Volume 2 - Introductory Chapters

Chapter 6

Description of the Proposed Development – Offshore

6. Description of the Proposed Development – Offshore

Image A6.1 Infrastructure of the proposed development – not to scale (Source: Arup) (Replacing Image 6.2 of the 2024 EIAR)

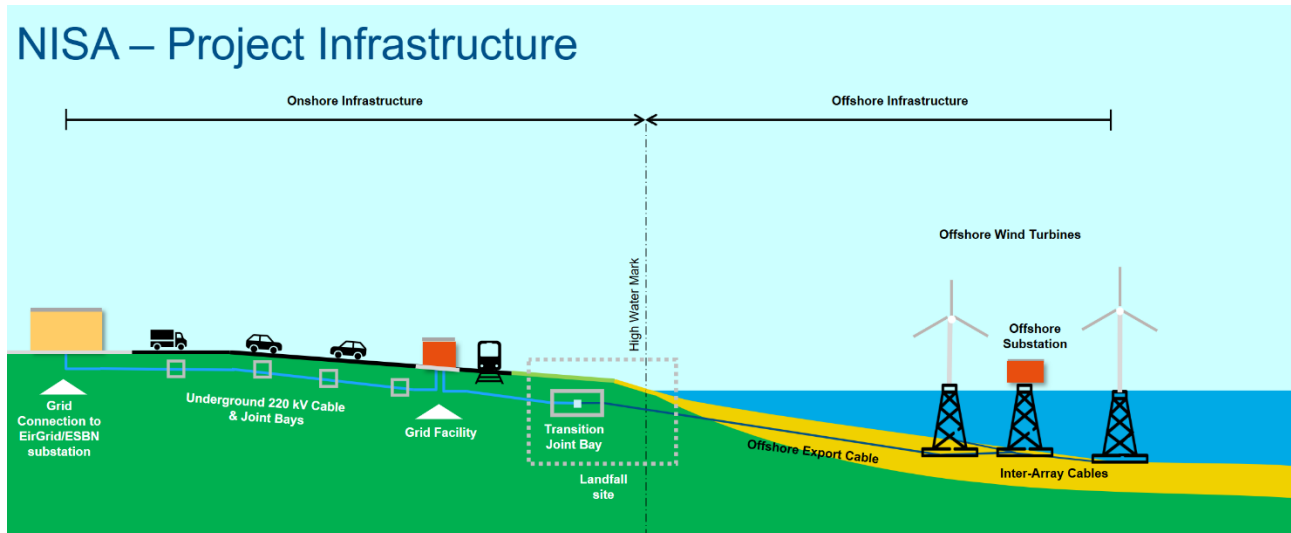
The only change required to Section 6.1 in Chapter 6 of the 2024 EIAR is in relation to Image 6.2. The image, which presented WTGs with monopiles, has been updated to show the WTGs with jacket substructures and suction bucket foundation and to remove the previous depiction of an ownership boundary, as this aspect is not relevant to the graphical illustration of the proposed development.

For the purposes of clarity, Image 6.2 from Chapter 6 of the 2024 EIAR shall be deleted and replaced with Image A6.1.
